Groundwater Application Review Summary Form

Application # G- <u>19068</u>

TO:	Water Rights Section		Date	6/29/2023	
FROM:	Groundwater Section	Joe Kemper			
		Reviewer's Name			
SUBJECT:	Application G 19068 _	Supersedes review of	11/19/2021

A. <u>GENERAL INFORMATION</u>: Applicant's Name: <u>Matt and Barbara White</u> County: <u>Deschutes</u>

Well Location Map

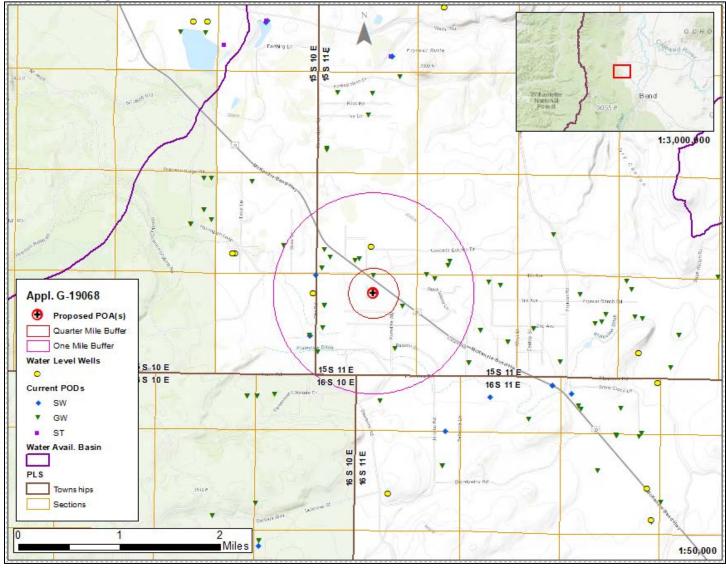
Applicant's Well #1 (Proposed Well): Applicant's Well #1 is a proposed well, therefore it cannot be reviewed for construction. Construction of this proposed well shall be completed in a manner that protects ground water resources as required under Oregon Administrative Rules 690-200 through 690-240. During construction of this well, specific attention should be paid to ensure sealing requirements are met and that the well does not commingle aquifers.

The construction of applicant's proposed Well #1 may not satisfy hydraulic connection issues.
